## **RESPONSE TO SUBMISSIONS: PROPOSED INDUSTRIAL FOOD MANUFACTURING FACILITY**

2 AND 14 DISTRIBUTION DRIVE, ORCHARD HILLS  
LOT 10 AND 11 DP 271141

Prepared by Willowtree Planning Pty Ltd  
on behalf of Snack Brands Australia

**3 February 2022**

**Figure 1 SBA Delivery Diagram** (Source: SBA, 2021)

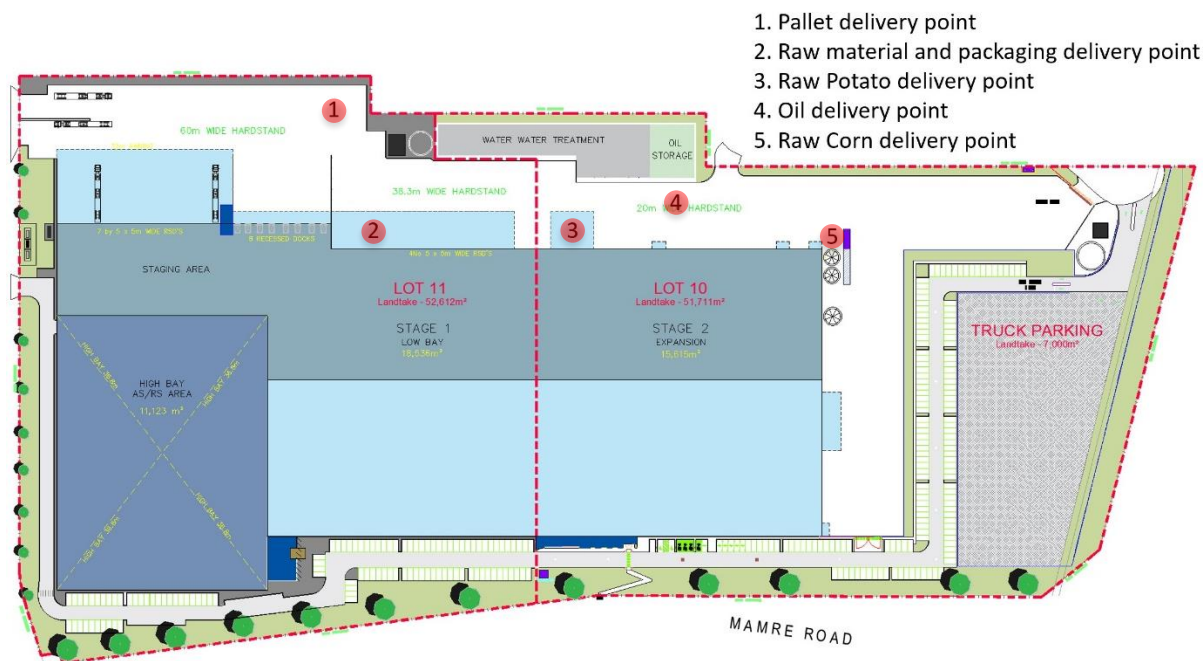
| TABLE 1: RESPONSE TO AGENCY SUBMISSIONS |                     |   |  |
|---|---------------------|---|--|
|   |                     | Table 9 of the EIS identifies the product inputs and outputs of the development's operations. However, other materials and products are delivered to the site including oils, flours and seasoning products which have not be identified in Table 9. Further information is required on the quantities (daily, weekly and annually) delivered to the site and the location of delivery acceptance on the site.  | Reference should be made to <b>TABLE 4</b> of this RTS Report, which include further detail on the quantity of oils, flours and seasoning products required for the proposed operations. |

**Figure 1** below shows the location of deliveries for the different materials and products. At point 2, deliveries will include packaging (cases, film, plastic film, cardboard cartons) and raw ingredients (rice flour, polenta flour, pellets and seasoning). These are all pallet-based quantities, as described in the submitted Operational Summary Report (Appendix 26 of the EIS).

**Figure 3 Wastewater Treatment Plant Process** (Source: SBA, 2021)

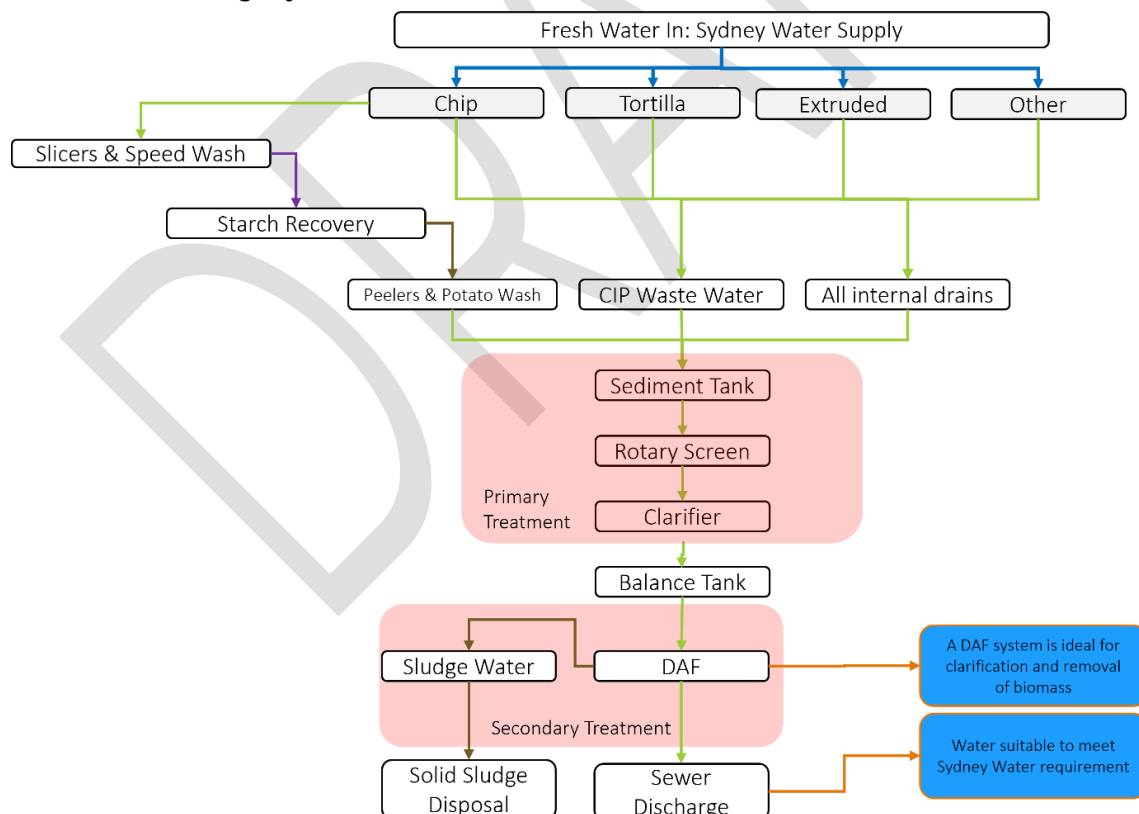
| TABLE 1: RESPONSE TO AGENCY SUBMISSIONS |                     |   |  |
|---|---------------------|---|--|
|   |                     | The development includes the construction and operation of a wastewater treatment plant. Further information on the operations and treatment processes of the proposed wastewater treatment plant including information on development wastewater sources to be treated and the transfer of the wastewater to the wastewater treatment plant is required.   | <b>Section 4.2.6.6</b> of this RTS Report provides further information on the operations and processes associated with the proposed wastewater treatment plant.                          |

The trade waste and pumping station will be designed to capture and treat the processing waste (from labs, airlocks and factory entries) within the site, it will not be design to treat effluent from the onsite bathrooms, change rooms or kitchens.

All effluent from site bathrooms, change rooms or kitchen transfers are expected to utilize the current First Estate sewerage system.

Figure 4 Updated Landscape Plan (Source: Geoscapes, 2021)

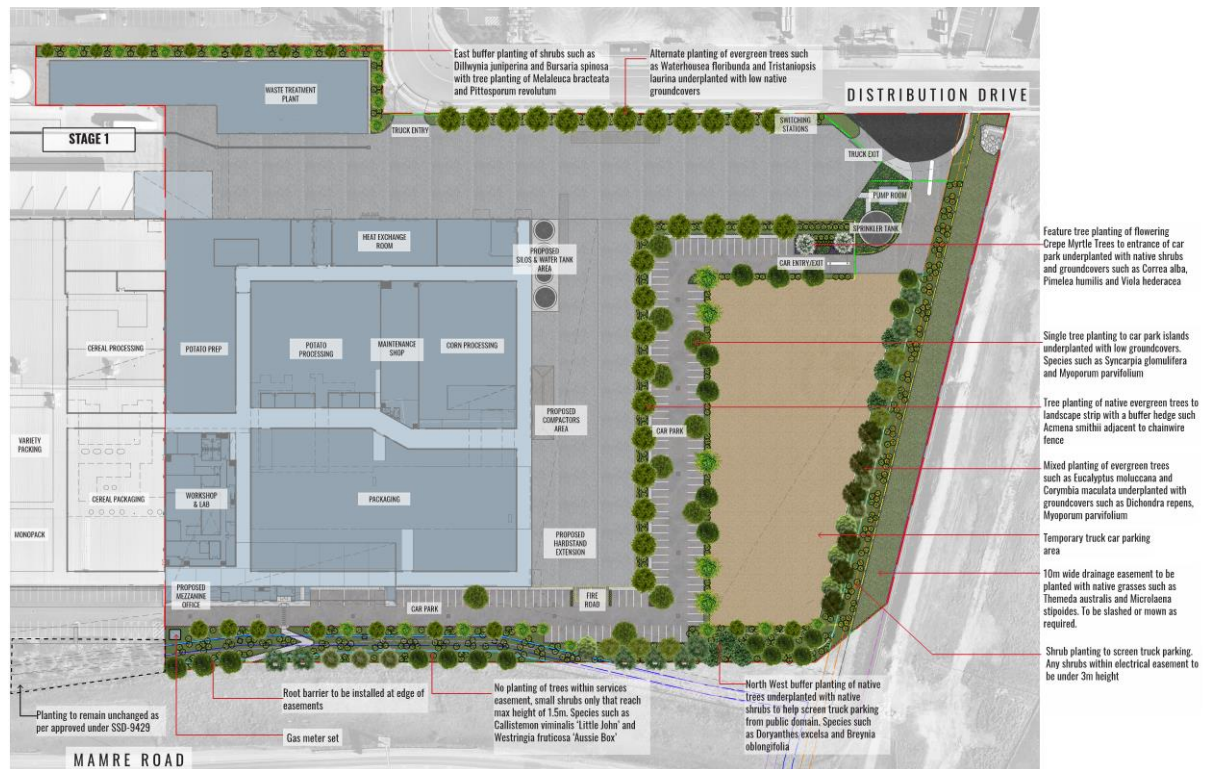
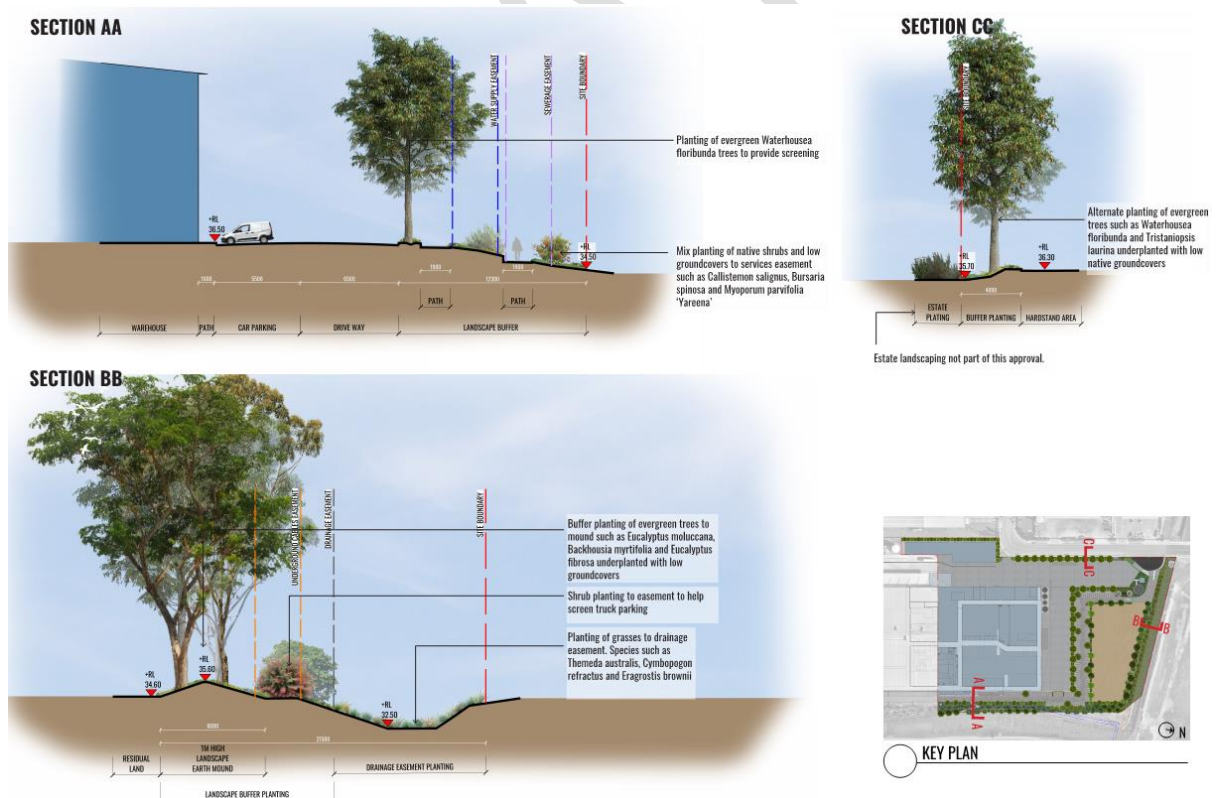
| SUBMITTER                   | MATTERS RAISED          | COMMENTS / REQUESTS   | FORMAL RESPONSE   |
|-----------------------------|-------------------------|---|---|
|                             |                         | <p>The landscape plans depict tree planting within the car park however the trees should be offset / staggered across both sides of the aisle to maximise canopy cover and shading opportunities in accordance with Council's Cooling the City Strategy. The current tree planting arrangement in the car park will not sufficiently assist to ameliorate the abundance of exposed hard stand parking on the site. The same offset principle should also be applied between the single trees in the parking area and the trees within the landscape strip between the parking area and the hardstand extension opposite the proposed compactors area. With the exception of one location, the trees are planted adjacent to each other which is a poor arrangement.</p> | <p>Landscape Plans have been updated to:</p> <ul style="list-style-type: none"> <li>offset trees across the parking aisle;</li> <li>amend tree pits to 3.4m wide; and</li> <li>incorporate structural tree soils to increase the available area under parking for root growth.</li> </ul> <p>These plans form <b>Appendix C2</b> of this RTS Report.</p> <p>As the site has been classified as an inner protection area (IPA) within the Bushfire Protection Assessment (Appendix 13 of the EIS), tree planting responds to the Rural Fire Service (RFS) <i>Planning for Bushfire Guidelines</i> to ensure that separations of 2-5m between mature canopies can be achieved. Therefore, due to these requirements</p> |

| SUBMITTER | MATTERS RAISED | COMMENTS / REQUESTS  | FORMAL RESPONSE   |
|-----------|----------------|--|---|
|           |                | The landscape strips for tree planting in the car park are also inadequate in size and dimension. A minimum of 2m width (if not greater) is required whereas the landscape design plan suggest only 1.0m (or less) is provided. This inadequate to achieve the canopy coverage required to meet the objectives of the car park tree planting requirements. This will necessitate further reduction in car parking to address these requirements. The resulting car parking numbers achievable would need to be reconsidered against the projected demand within the Traffic and Parking Assessment and if there is a shortage, redesign to accommodate the required parking would be expected. | and the width of the available landscaping, trees are required to be planted in a row. The exception to this is on the bund, where staggered tree canopies are likely to touch, however shrubs are not placed under these areas and located some distance from the building.<br><br>This landscaping approach was approved by Travers Bushfire and Ecology, within their assessment of Geoscapes landscaping plans.   |

| SUBMITTER | MATTERS RAISED   | COMMENTS / REQUESTS   | FORMAL RESPONSE  |
|-----------|------------------|---|--|
|           | Landscape Design | <u>General Comments</u> <ul style="list-style-type: none"><li>The proposed plant species diversity as represented in the submitted schedule is satisfactory, however a diverse use of the species should be applied to all planted areas to encourage biodiversity, resilience and interest.</li><li>Canopy planting should be maximized to reduce the visual impact of the development, particularly the tall Snack Brands built forms to the south, compensating for the very limited tree planting that has been delivered as part of this approval.</li></ul>                         | <p>Landscape Plans have been updated to:</p> <ul style="list-style-type: none"><li>Increase the diversity and numbers of shrubs species; and</li><li>Increase, where possible, the diversity in trees and groundcovers.</li></ul> <p>As described in an earlier comment, the entire site has been classed as an IPA and the current landscape drawings have been assessed by Travers Bushfire and Ecology in meeting the RFS requirements. Therefore, an increase to canopy cover would result in tree canopies touching and conflicting with bushfire guidelines.</p> <p>Notwithstanding, further trees have been incorporated around the temporary truck parking area.</p> <p>Updated Landscape Plans form <b>Appendix C2</b> of this RTS package.</p> |

**Figure 4** and **Figure 5** show the extent of landscaping now proposed, in response to Council's submission.
